COUNCIL ASSESSMENT REPORT

Panel Reference	PPSSNH-636
DA Number	eDA0189/25
LGA	Ku-ring-gai
Proposed Development	Demolition of existing structures and construction of a residential flat building with basement car parking and associated works.
Street Address	7-11 Pockley Avenue, Roseville
Applicant/Owner	Applicant: Place Studio AU Pty Ltd Owner: Mr DAS Mathews, Mrs SK Mathews, Mr A Berenjforoush, Mrs N Asadi, Mrs LC Sansome
Date of DA lodgement	28/04/2025
Total number of Submissions	Ten submissions
Total Number of Unique Objections	Ten unique objections
Recommendation	Refusal
Regional Development Criteria - Schedule 6 of the SEPP (Planning Systems) 2021	General development over \$30,000,000
List of all relevant s4.15(1)(a) matters	• SEPP (Planning Systems) 2021 (SEPP PS) • SEPP (Housing) 2021 (SEPP Housing) • SEPP (Resilience and Hazards) 2021 • SEPP (Sustainable Buildings) 2022 • Ku-ring-gai Local Environmental Plan 2015 (KLEP 2015) • Ku-ring-gai Development Control Plan (KDCP) • Ku-ring-gai Contributions Plan 2010

To determine Development Application No. eDA0189/25 for demolition of existing structures, lot consolidation and construction of a residential flat building development

Figure 9: plan showing drainage lines within the road network

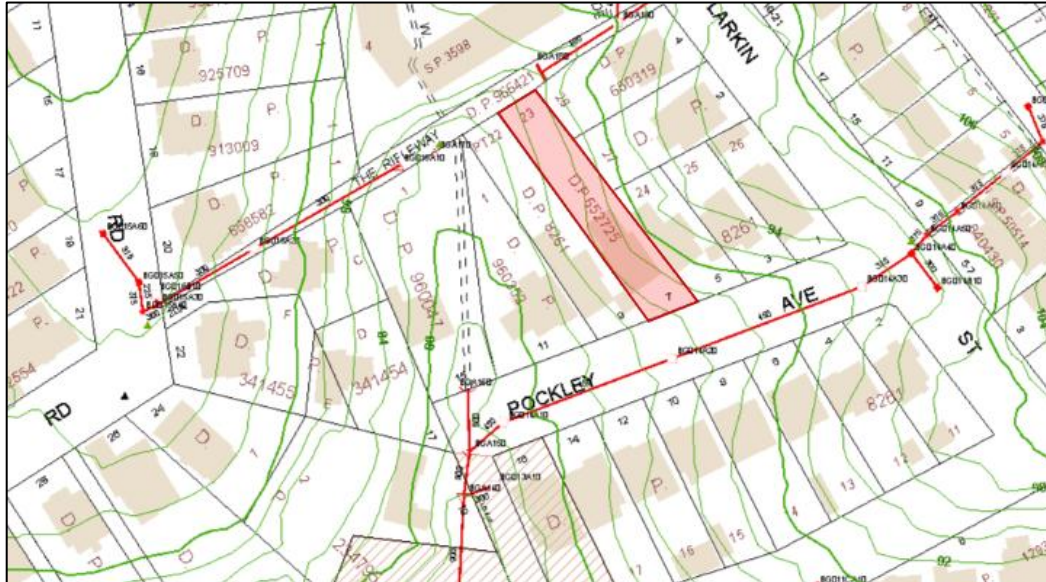
The stormwater plans show all roof areas to be collected and conveyed to a combined detention and retention tank of 63.06m³ and 12,370 l respectively, located beneath the driveway area. The overflow from the detention system is directed to the bottom of the existing drainage channel via a 225mm pipe located in Pockley Avenue.

There is a requirement also to provide a kerb inlet pit near the bottom and a pipe to the existing pipe at the headwall outside No. 15 Lockley Avenue. This would require modification of the headwall. The proposed drainage would need to be connected to the new kerb inlet pit via a 225mm pipe as proposed discharging to the existing swale will not be supported.

Figure 10: plan showing overland flows

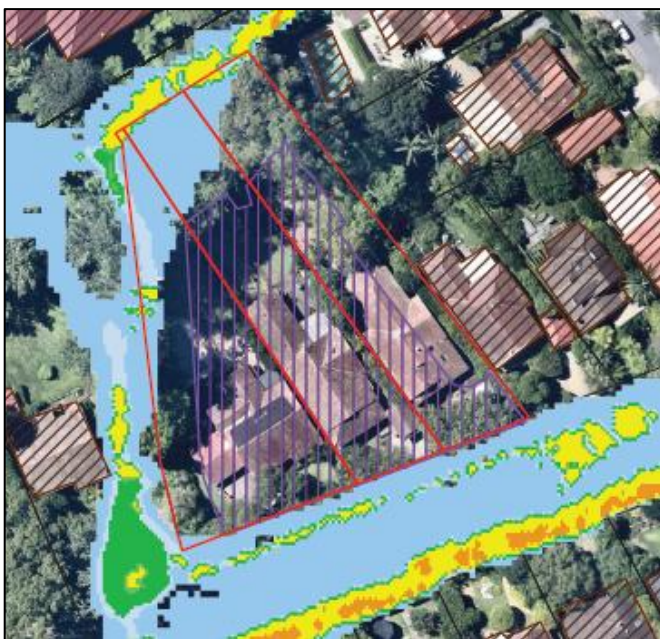
The subject site is impacted by overland flows, as shown in **Figure 10** below. The topography and drainage patterns of the subject site are generally as follows:

- i. The site is flooded from upstream flows during the 1% AEP storm event, with depths generally 100mm reaching a maximum of 360mm at the north-western side of the site.
- ii. The flood level within the subject site is RL 84.5m AHD to the north-eastern corner, RL 78.25m AHD to south-western corner and RL 87.0m AHD to the south-eastern corner.

The subject site is classified as being generally hazard category H1 with minor pockets ranging between H2 to H5 (H1 being generally safe for vehicles, people and buildings and H5 being unsafe for vehicles and people. All building types vulnerable to structural damage. Some less robust building types vulnerable to failure). As a result, future occupants will not be exposed to risks associated with the hazardous areas identified within the site being present away from the habitable areas, as the site is assessed as an H1 flood hazard area

Figure 11: plan showing sight line as dashed colour red

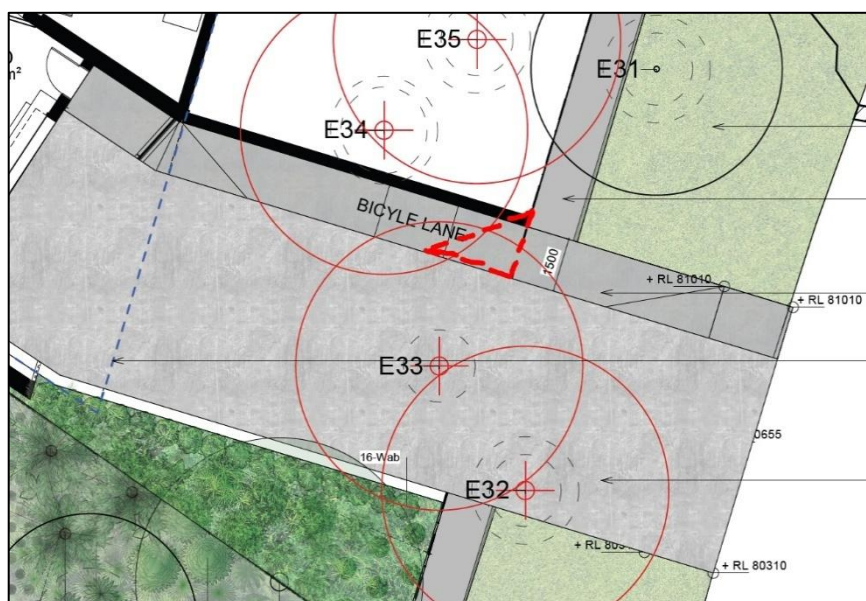
There is a minor non-compliance in the provision of the 2m x 2.5m sight triangle as per AS2890.1 (shown in red below), but this could be conditioned to be corrected:

- a) The parking provision should be reduced to the lower end of the range in the DCP and supplemented with at least 1 car share vehicle.
- b) Remote/intercom communications be provide at the access gate next to the basement shutter door, so visitors can communicate with the occupants to access the bicycle parking. This is to be depicted on the architectural plans.
- c) The access point is to be amended to accommodate the 2m x 2.5m sight triangle as per Figure 3.3 of AS2890.1:2004.

Figure 12: plan showing the 22 metres building height plane

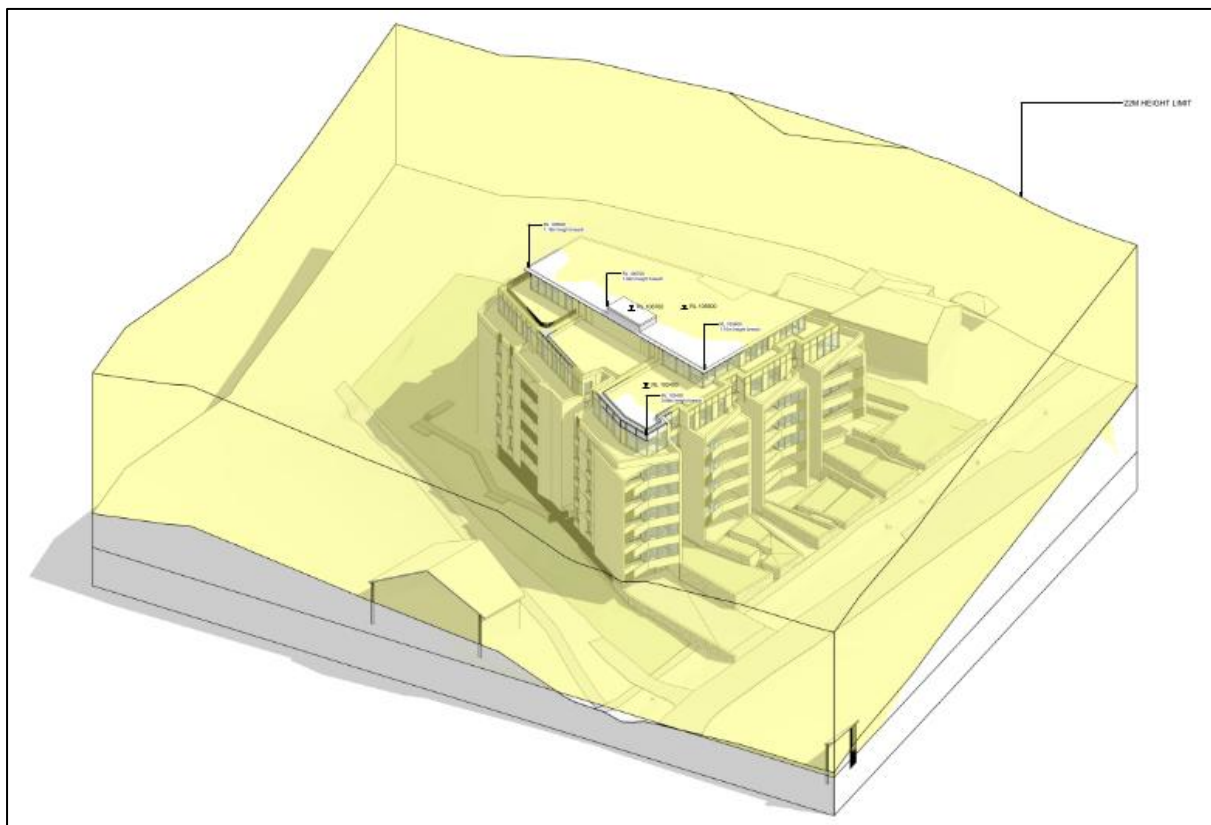
- c) Referring to **Figure 14** below, the height plane provides insufficient information:
- i. the natural ground level, that is annotated on the survey plan, is not shown on the Height Plane Diagram and Sections.

- ii. the Height Plane Diagram does not provide an accurate calculation of building height, as it utilises ceiling levels, for example RL102.4 for the breach in relation to Unit 5.01. The breach is caused by parapet and roof levels, which are above the ceiling level, and

The Clause 4.6 request is incomplete for the above reasons and therefore cannot be supported and therefore form the basis of the reason not to support the request to vary the maximum height development standard.
